A8 Bolt Structure For Use With a Magnesium Alloy Member For Tightening Magnesium Alloy Members With Each Other Or With A Heterogeneous Material

REMARKS

Claims 1-6 are pending and Claims 1-6 have been objected to and rejected. In this amendment, Claims 1-6, the specification, the title, and the Abstract have been amended. No new matter has been added.

Fig. 6

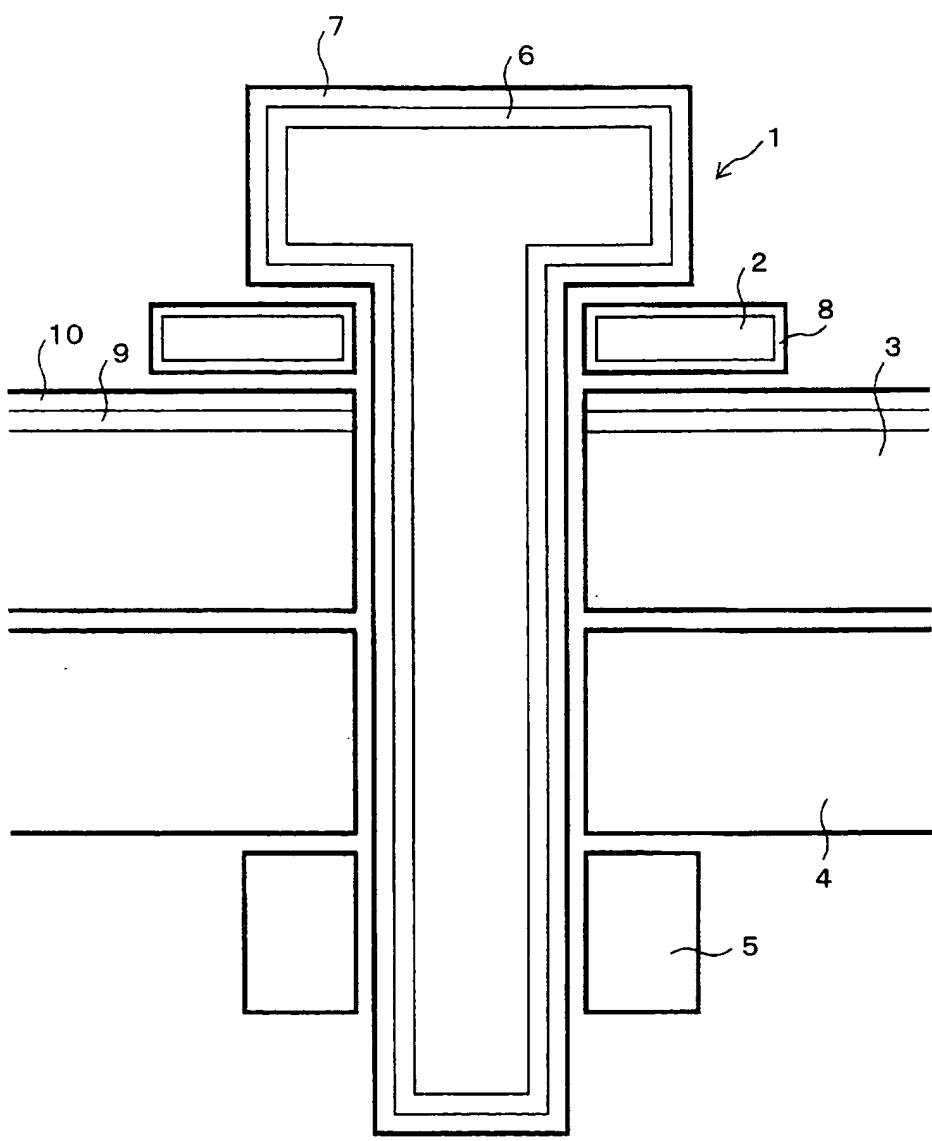
The drawings have been objected to under 37 CFR 1.83(a) as not illustrating every feature of the invention specified in the claims. Applicants have attached to this Response

a Proposed Figure 6 for the Examiner's consideration. It is submitted that Figure 6 illustrates all of the features of the claimed invention. In Fig. 6, a bolt 1 fixes a magnesium alloy member 3 and a magnesium alloy or heterogeneous material member 4 with a nut 5 through a washer 2. The bolt 1 is plated by zinc-nickel and then is treated with Cosmer chromating solution. Therefore, a zinc-nickel plating layer 6 and a Cosmer treatment layer 7 are provided on the surface of the bolt 1 in this order. The washer 2 is made of aluminum and is subjected to an alumite treatment, thereby providing an alumite-treated layer 8 on the surface of the aluminum washer 2. The magnesium alloy member 3 is electrodeposited by cationic electrodeposition and then is powder-coated on a surface faced to a head of the bolt 1. Therefore, an electrodeposition coating 9 and a powder coating 10 are provided on the surface in this order. It is requested that the objection be withdrawn.

A7 Fig. 6 shows an embodiment of the present invention, including a bolt structure (1), a magnesium alloy member or heterogeneous material member (4), a nut (5), a cationic electrodeposition coating (9), a powder coating (10), aluminum washer (2), a magnesium alloy member (3), an alumite-treated layer (8), zinc-nickel plating layer (6) and the cosmer treatment layer (7).
